Conversion of Nether Mill Barn, Penistone S36 8AD
To form Veterinary Surgery on Behalf of Donaldson's Vets Ltd

Our Ref: C1096 453; Statement to Accompany an Application to Vary Planning Condition 2 (Planning Application Ref: 2022/0744)

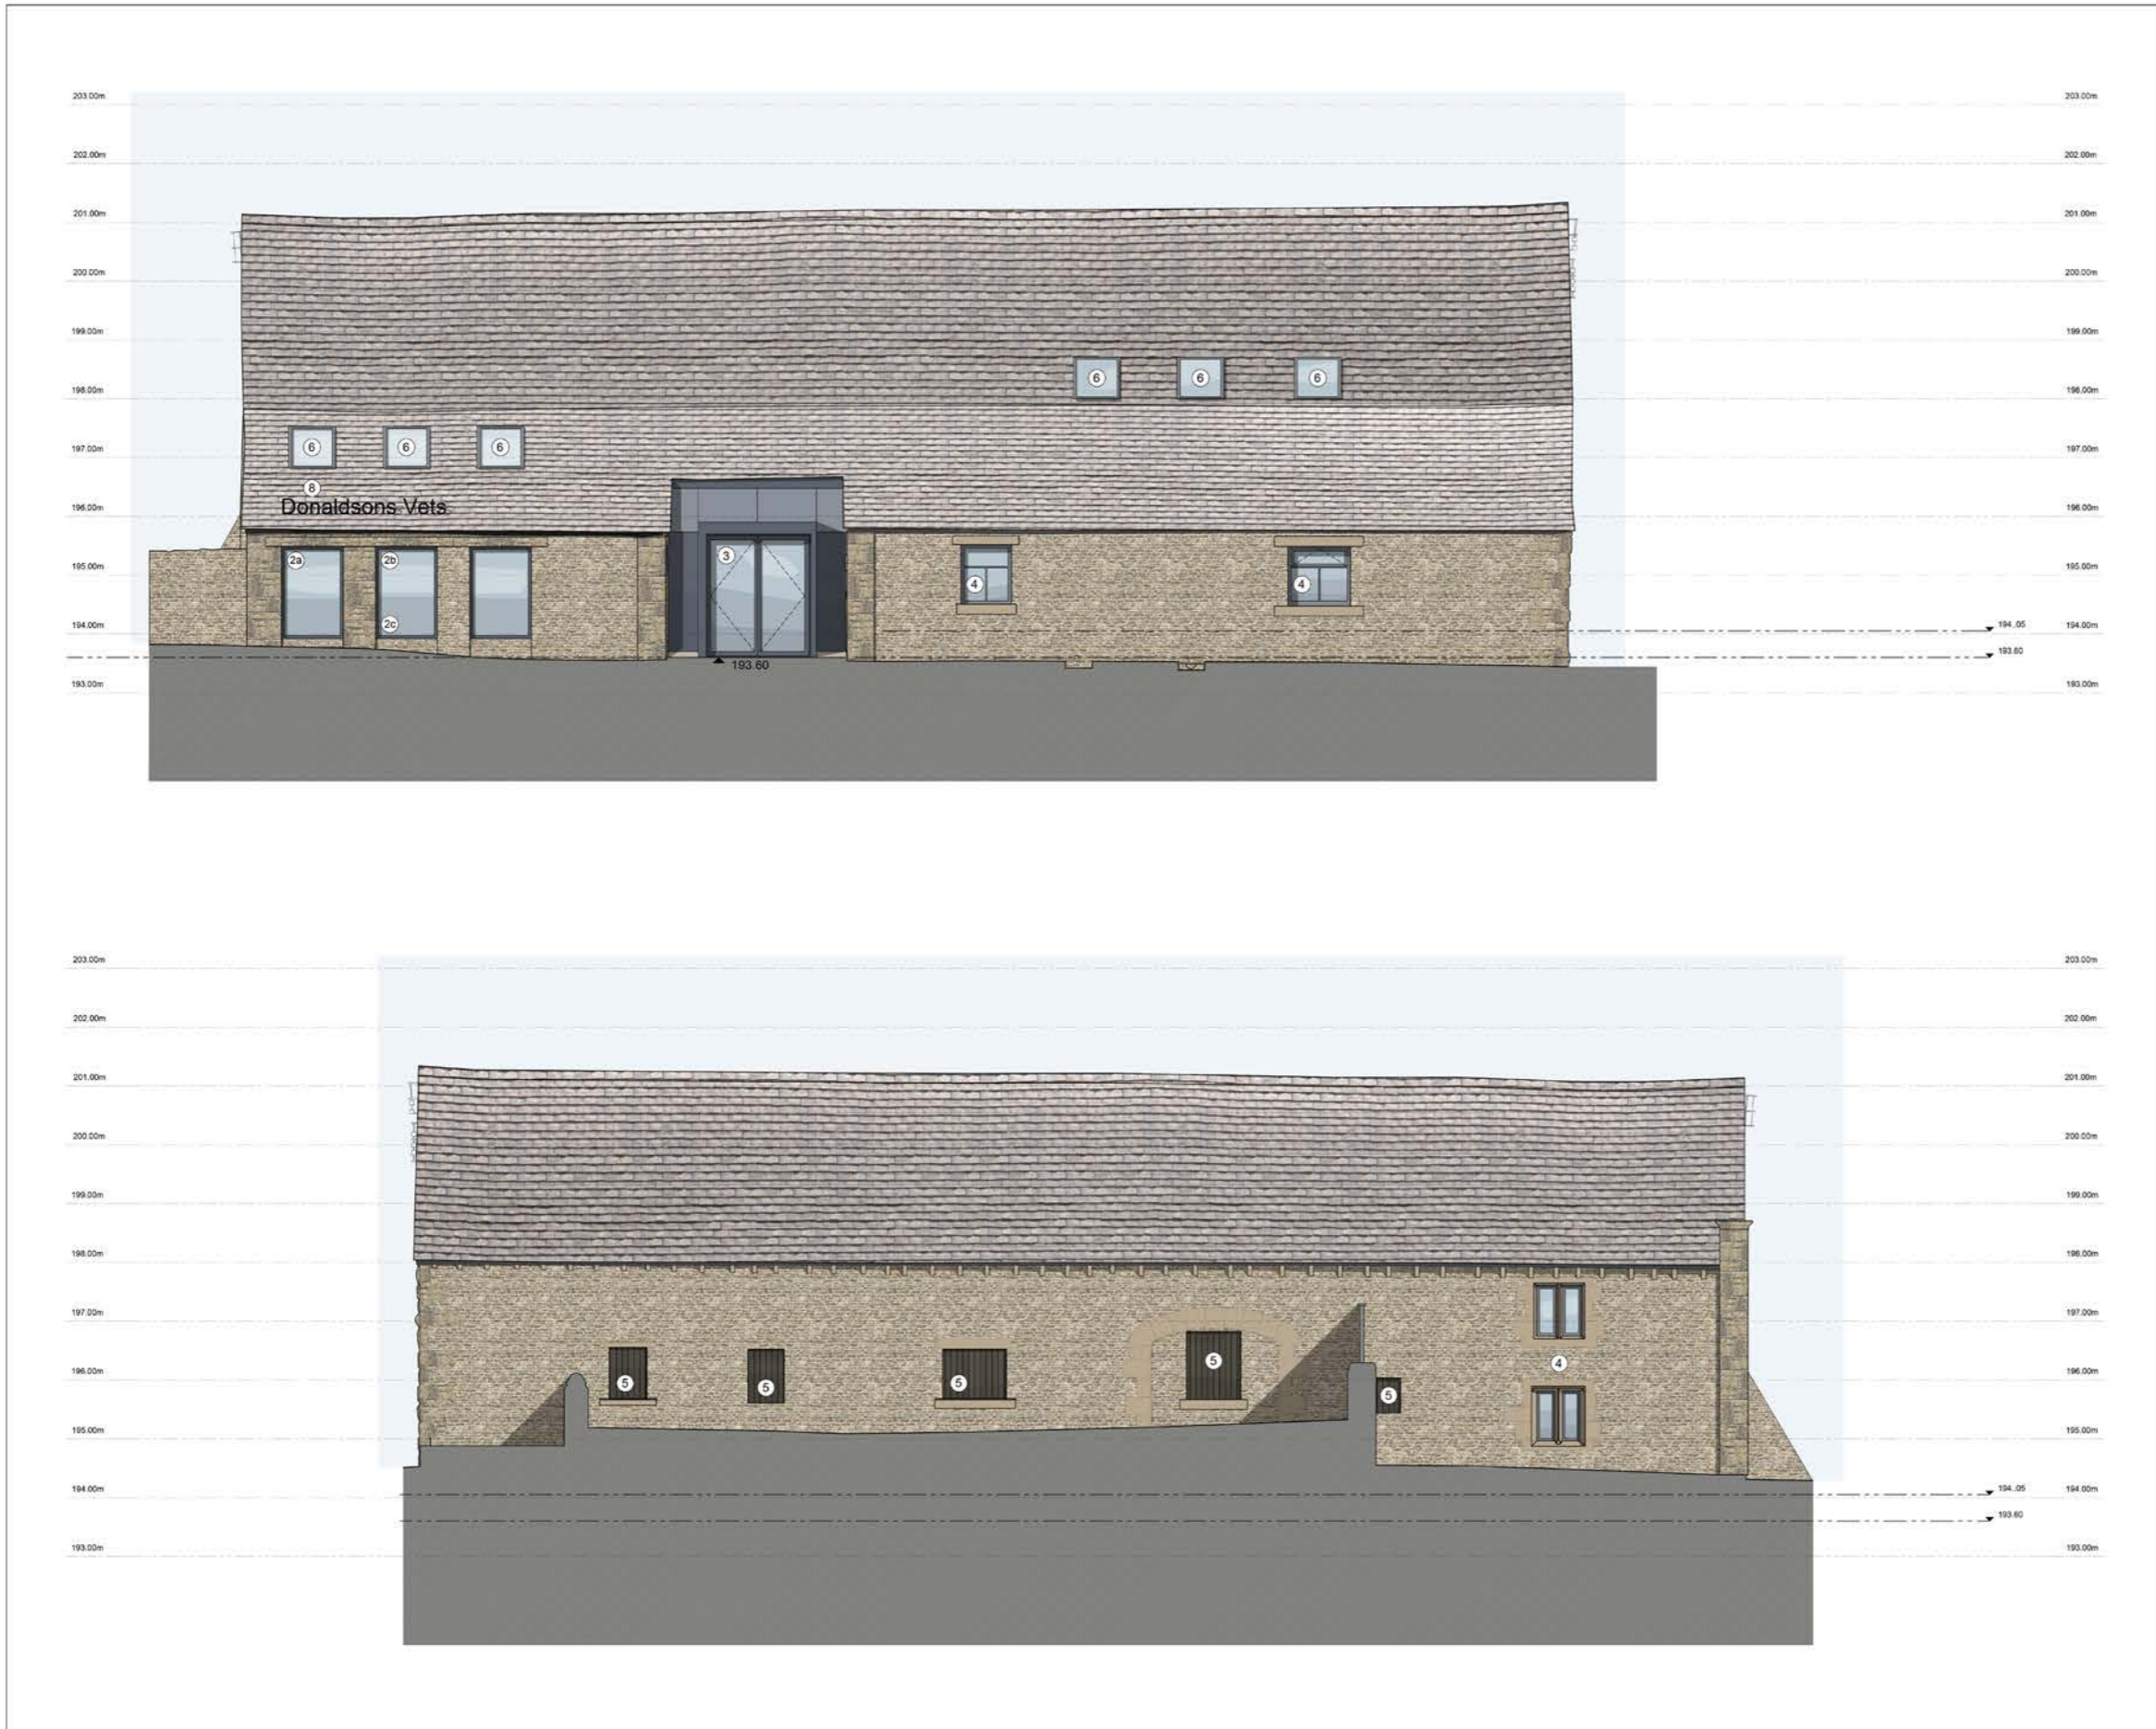
View of the existing gable with render partially removed,
Evidence of loose stonework is identified by the yellow dotted lines

View of the existing gable with render partially removed,
Evidence of 'bowing' wall pushing out above the buttresses

View of the existing gable with render partially removed,
Evidence of 'bowing' wall pushing out above the buttresses

C1096 201 Rev 9

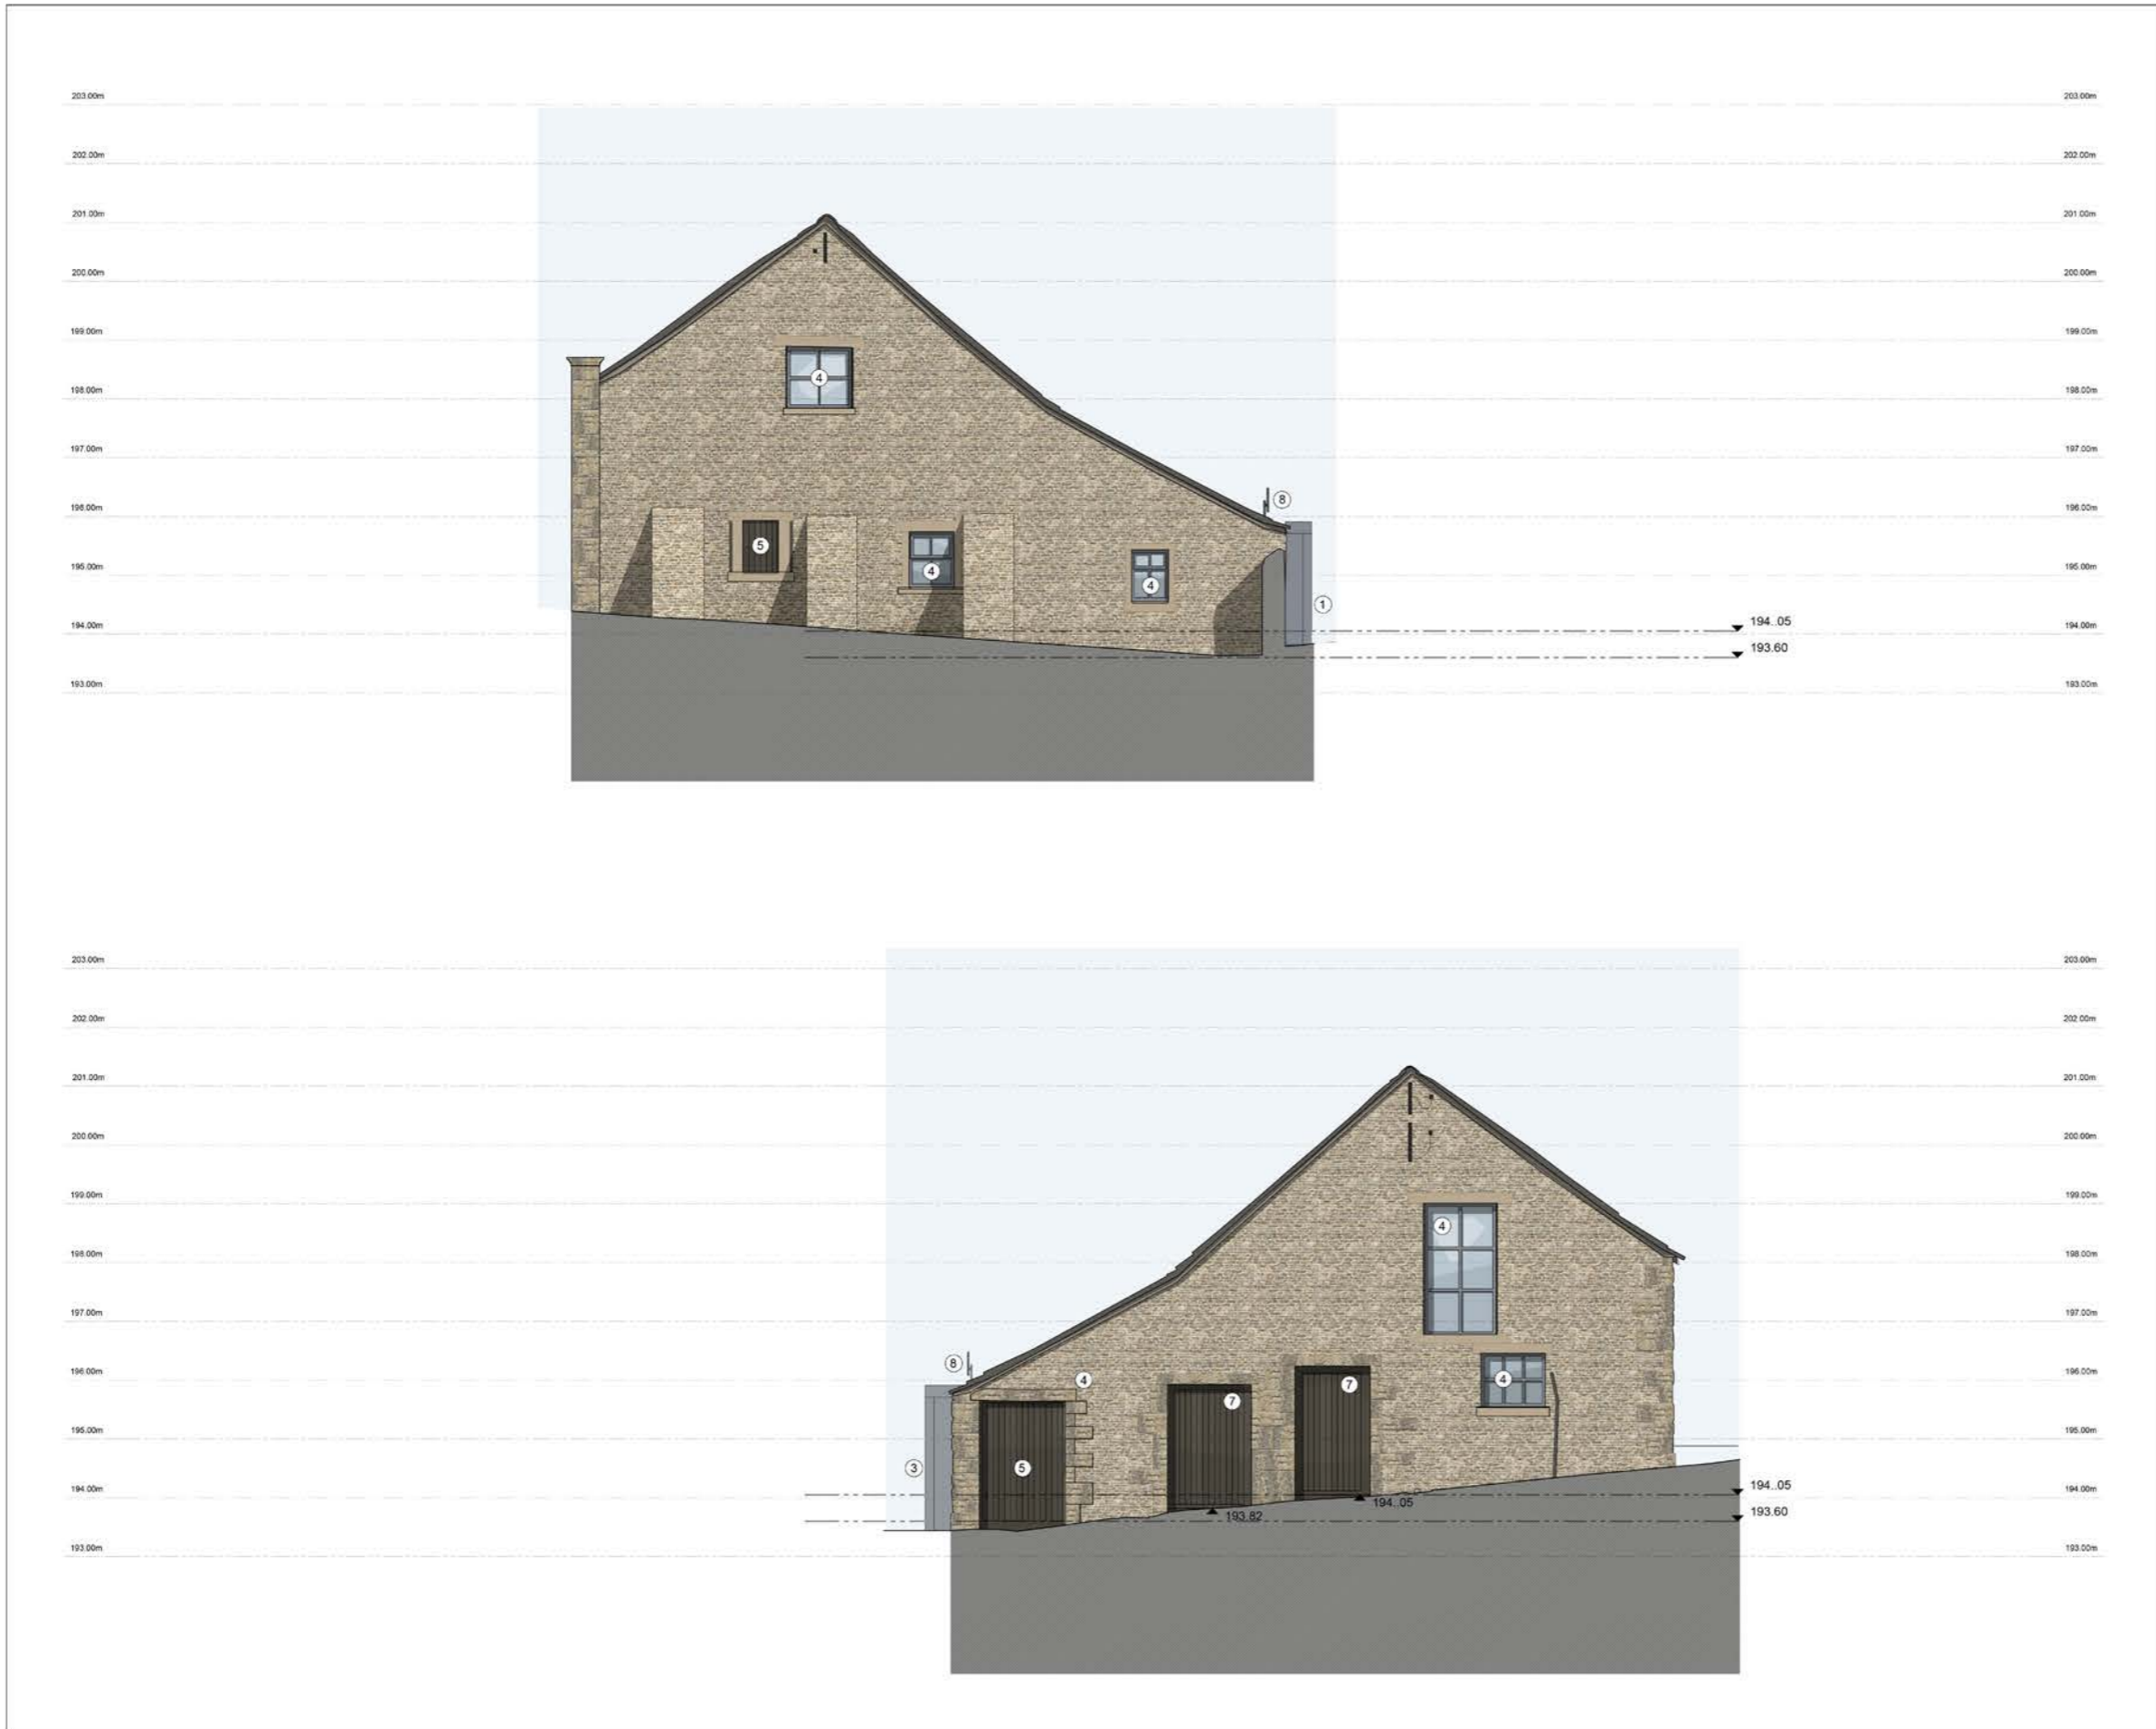
Rev 9
 2024.03.10 Brickwork buttressing removed as per demolition scope updates. Proposed works to existing stone updated

Rev 8
 2024.02.27 Stonework repair / replace annotations added, as per Gate & Bar comments

- Existing stone walling to be taken down (see Dawson Williamson Ltd drawing ref: C1096 050, 051, 052,053), retained on site, dressed for re-use and re-built in the recessed panels to the arrangement shown (2c)
 New natural stonework is to be used to form the higher, intermediate panels between the new openings
 New natural stone sills & heads to be fixed to form openings
